APPLICATION NO.	FILING DATE	FIRST NAMED INVENTOR	ATTORNEY DOCKET NO.	CONFIRMATION NO.
10/571,880	11/03/2006	Herbert Wehler	10016.510	2658
39231	7590	01/06/2011		
SMITH LAW OFFICE 8000 EXCELSIOR DRIVE, SUITE 301 MADISON, WI 53717				
EXAMINER				
STRIMBU, GREGORY J				
ART UNIT		PAPER NUMBER		
3634				
MAIL DATE		DELIVERY MODE		
01/06/2011		PAPER

### Office Action Summary

FIG. 3

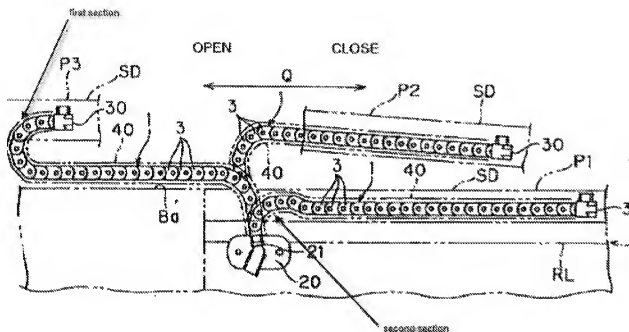
Claim 22 is rejected under 35 U.S.C. 102(e) as being anticipated by Kobayashi et al. (US 2004/0003543). Kobayashi et al. discloses an energy guide chain system for a vehicle, the vehicle having a chassis B and a sliding door SD that can be moved between a closed position and an open position on the chassis, and the energy guide chain system comprises:

a carrier 30 connected to the sliding door; and

an energy guide chain 1 having:

a first end connected to the carrier 30 and a second end connected to the chassis at 21; and

a region (not numbered, but shown in figure 3) between the first end and the second end, and the region has a first section (labeled below) that defines a first radius of curvature when the sliding door is in the open position, and a second section (labeled below) that defines a second radius of curvature when the sliding door is in the closed position.
